## Board of Architectural Review

DATE: February 7, 2024  
TO: Board of Architectural Review Chair and Members  
THROUGH: Jason Sutphin, Community Development Division Chief JDS  
FROM: Anna Kohlbrenner, BAR Liaison AK  
SUBJECT: **Public Hearing: 10306 Eaton Place – Willow Wood**

1. Case Number:	BAR-23-00041
2. Address:	10306 Eaton Place
3. Request:	Mixed-use building
4. Applicant:	Capital City Real Estate LLC
5. Applicant's Representative:	Evan Pritchard
6. Status of Representative:	Attorney
7. Zoning:	CR Commercial Retail, Architectural Control Overlay District

## 1 WEST ELEVATION

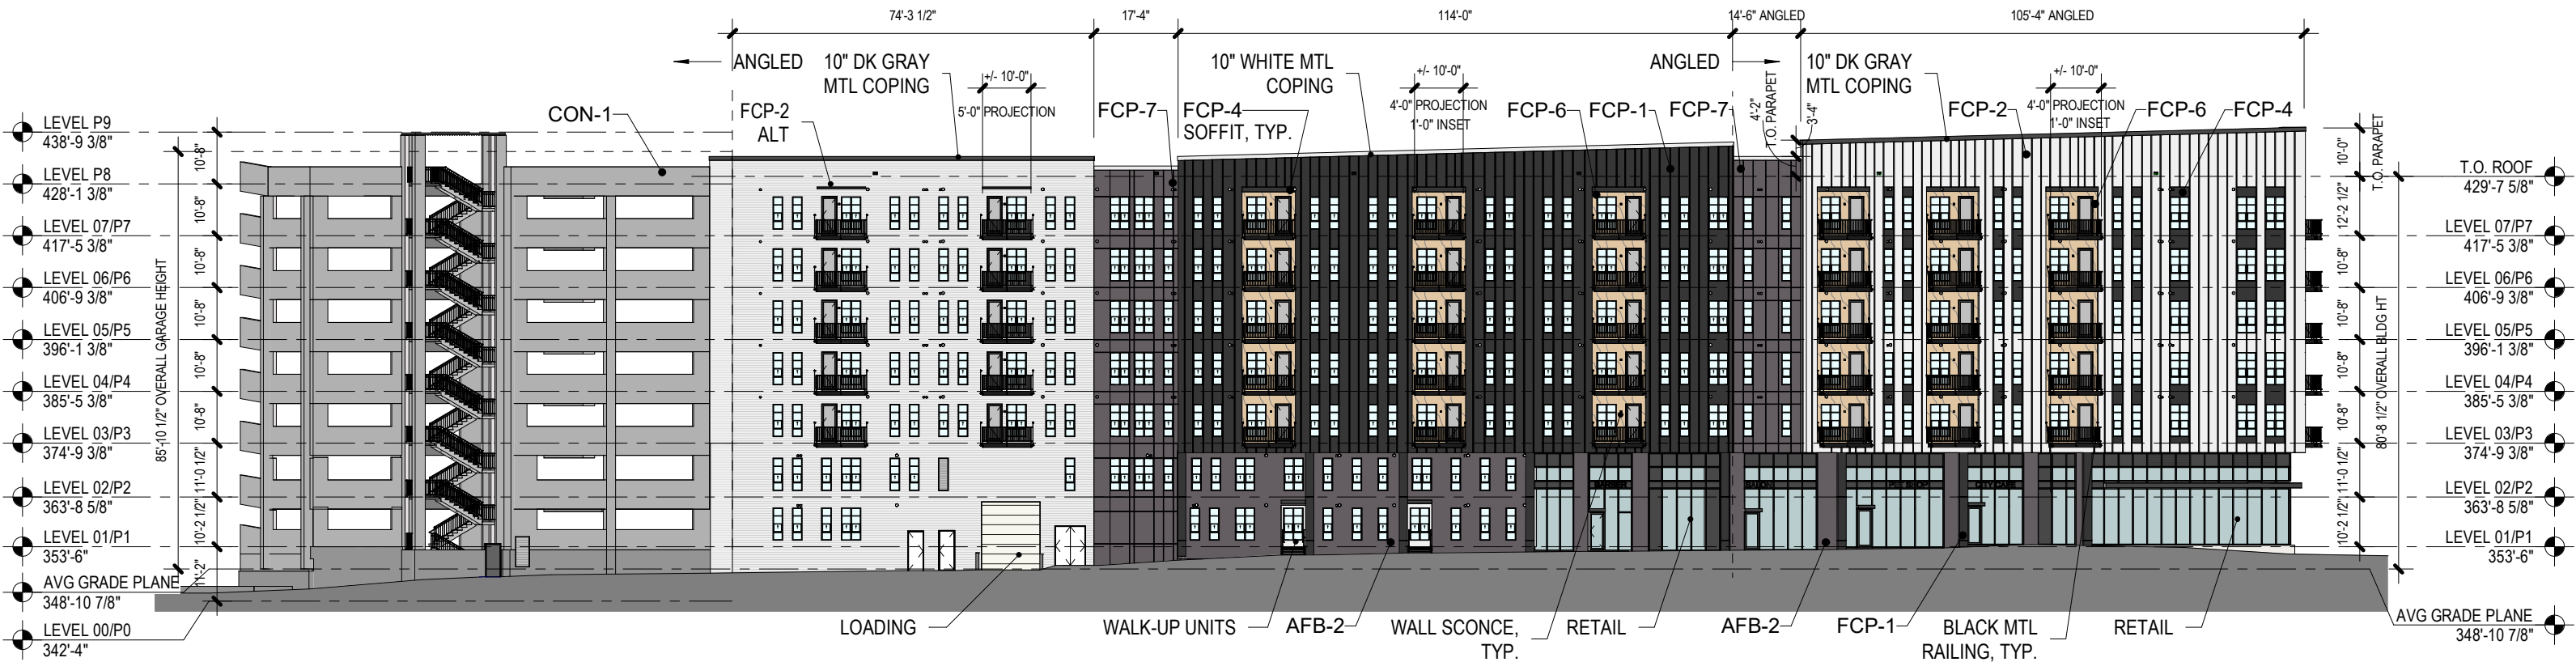
The applicant has increased interest along the western façade by adding breaks in the massing since the previous meeting with inseting the proposed balconies 1'.

The applicant has added a 10' metal coping along the roofline to add interest. Instead of the western elevation being very flat as seen at the previous meeting, the applicant has inset the roofline in some areas to add interest and has inset some balconies on the western façade and the corner of the southern façade.

Waye stated it would be nice to maintain a datum line on the retail storefront on the west elevation, because it looks like it drops down.

Beaty stated the west elevation needs work to differentiate it as it all appears very uniform. He stated he likes the mural on the east elevation. He stated the applicant is heading in the right direction, but they are not there yet.

Schroeder stated he is comfortable with the south and east elevations, but he is really struggling with the west elevation. He stated the west elevation is very long with no breakup with the precast concrete parking garage. He stated there needs to be something to hide the garage better. He stated the applicant is close, but the west elevation needs work.

Beaty stated the major problem is the long western façade.

Since the previous deferral meeting, the applicant has further broken up the western façade. Changes since the previous meeting along the western façade include an additional inset bay, changes in color locations of fiber cement in addition to an added color, inset balconies 1' on the two bays closest to Eaton, fiber cement soffit, additional brick along the retail portion, and increased metal coping along the roofline. Changes to other façades include staining the precast parking garage on all sides and inset balconies in the western corner along Eaton in the front elevation.

## 1 EAST ELEVATION

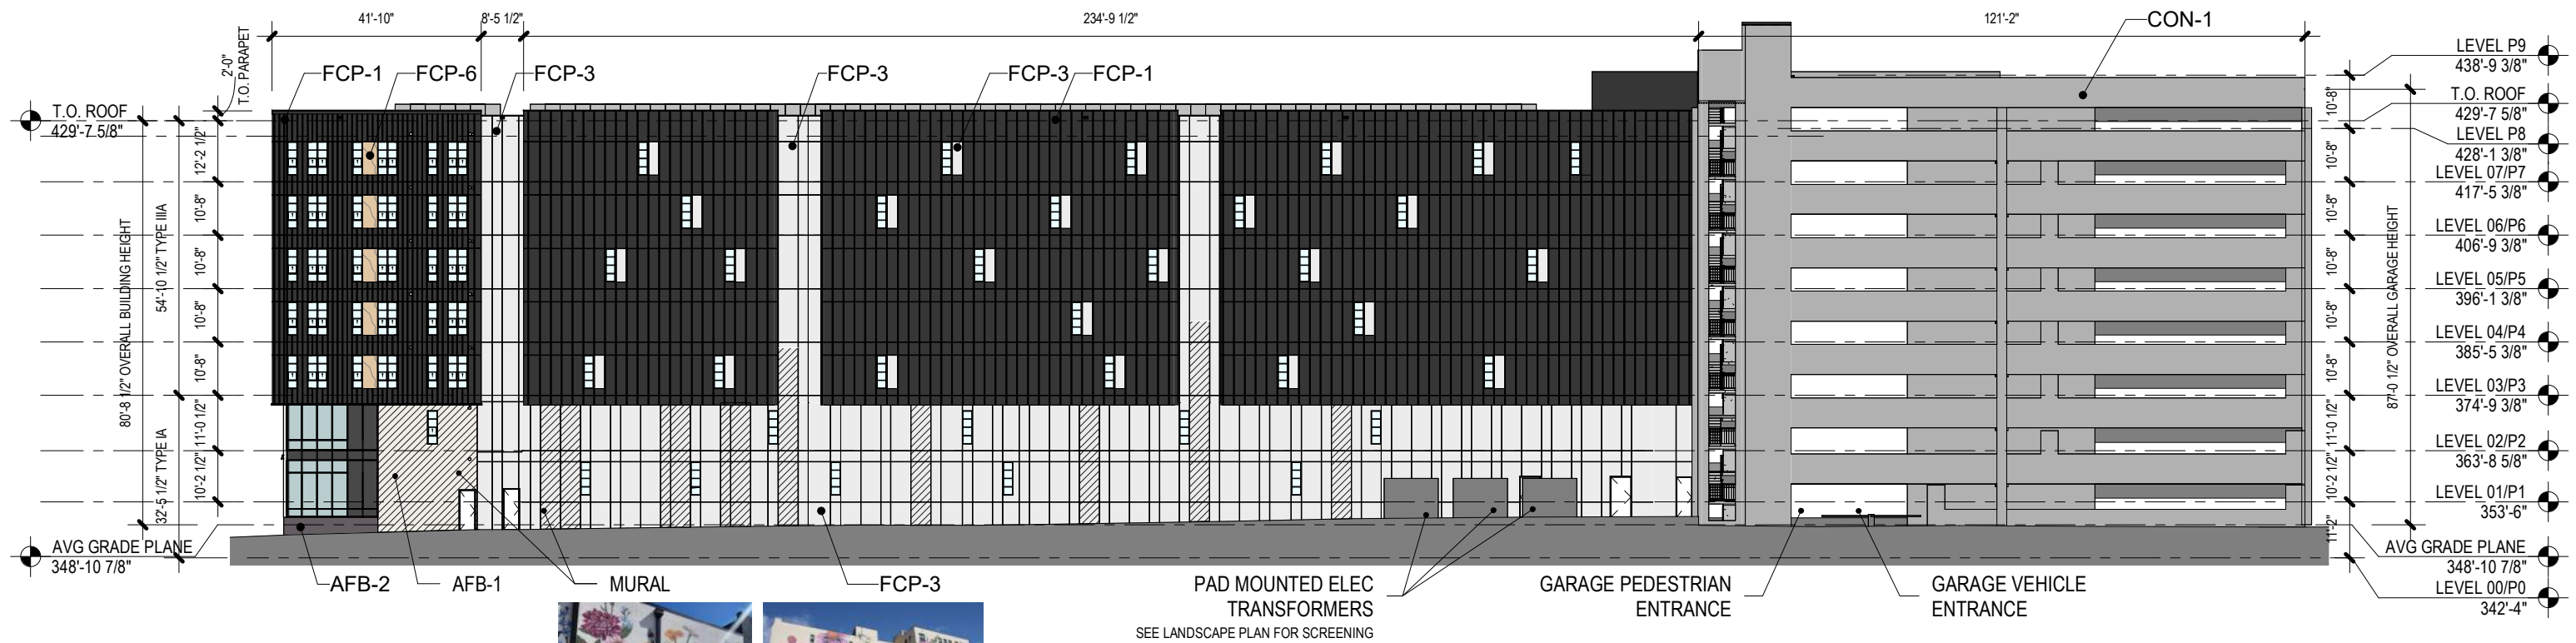
The applicant is proposing brick on the west and south sides of the building but only up to the second floor. The east side of the building does not have brick, only fiber cement and concrete.

Waye stated she likes the wood panel that was added behind the balconies. She stated in the east elevation, she appreciates how the applicant is starting to break up the façade more. She stated she is on the fence about the green wall and stated she was curious about the day-to-day maintenance of it. She asked if birds nest in it.

Singleton stated the murals proposed in the east elevation would make or break the project.

The storefront portion is proposed on the first floor of the mixed-use building. The applicant has incorporated artwork on the east elevation and outdoor seating is seen along the frontage.

# BECKERT'S PARK

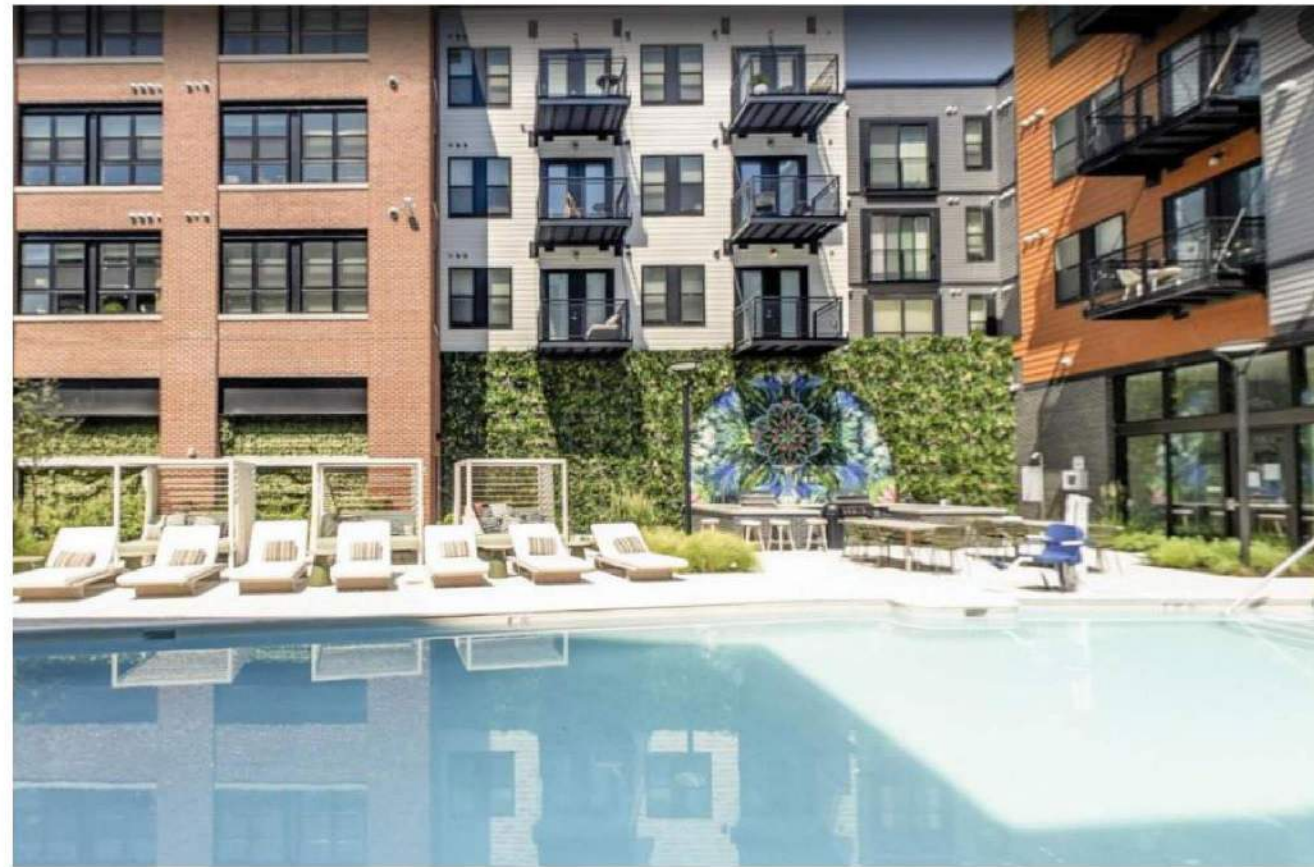
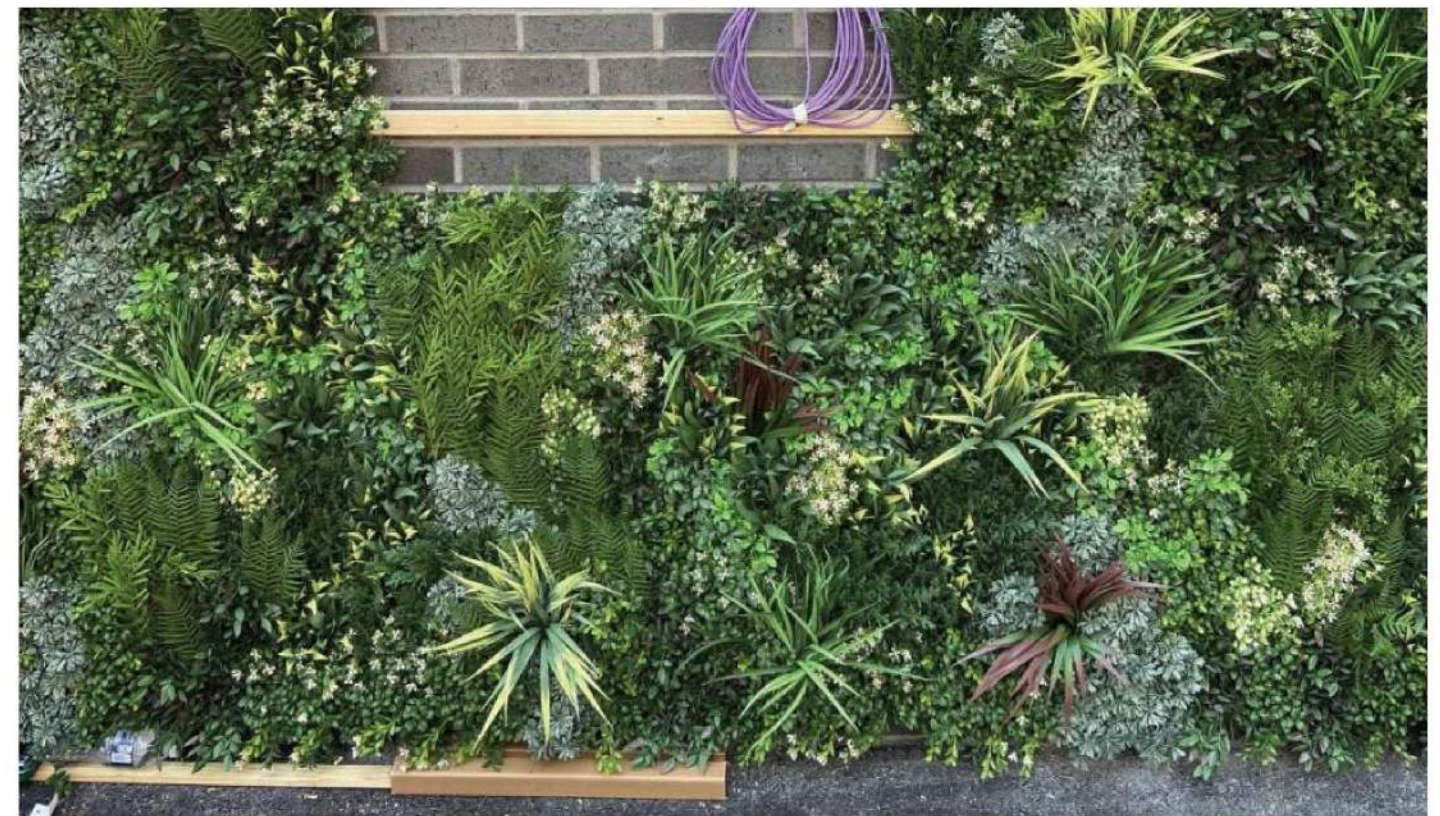
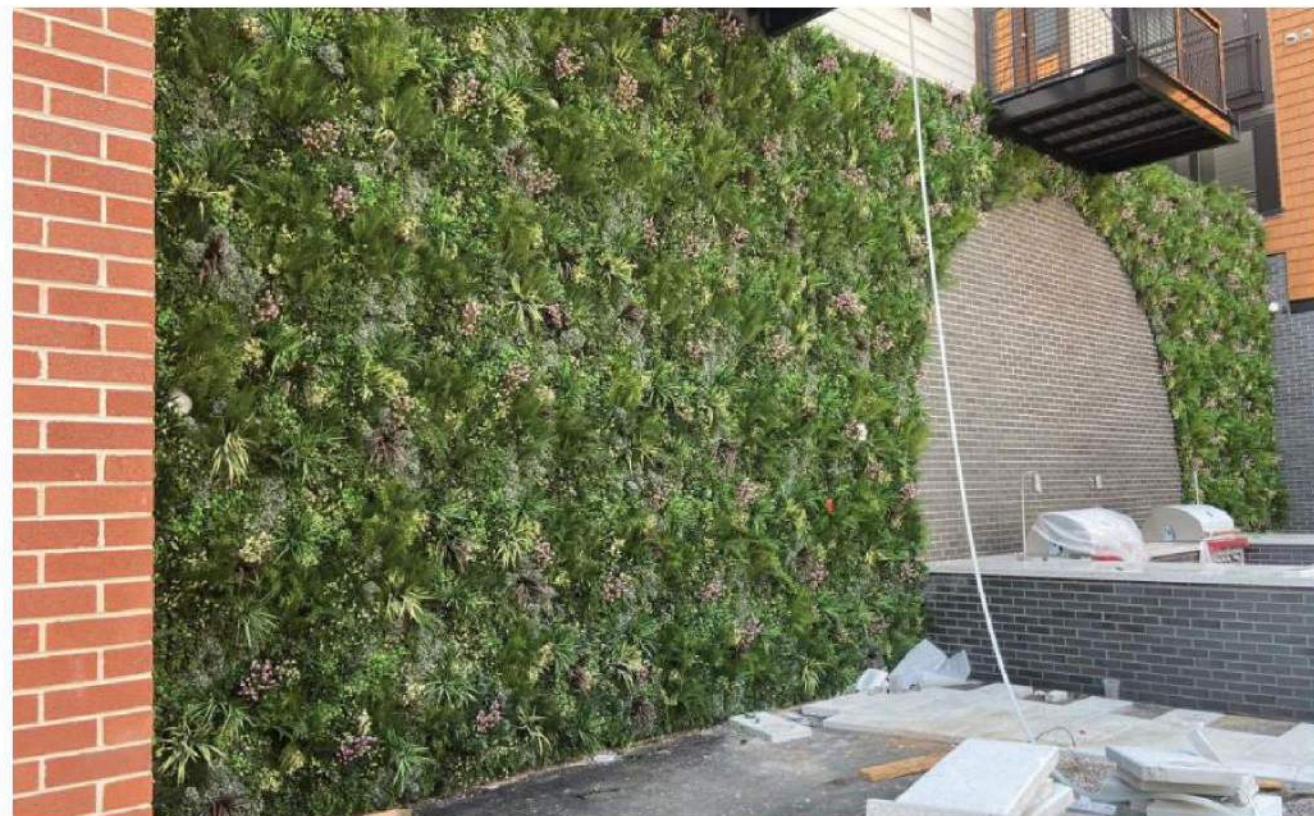
Feather stated there is a challenge in how the proposal fits in with the location. He stated they are not trying to match what surrounds the location and generally thinks it is appropriate. He stated he does have some questions about maintenance of the green wall.

Singleton stated the green wall at Beckert's Park in DC has been there for about three years and looks good still.

Beaty stated parts of the green wall looks plastically. He stated the south elevation has improved since the initial presentation. He asked the length of the building on the west elevation.

The applicant stated he does not think so because it is tightly woven. He stated this green wall system is seen in DC and it is UV protected.
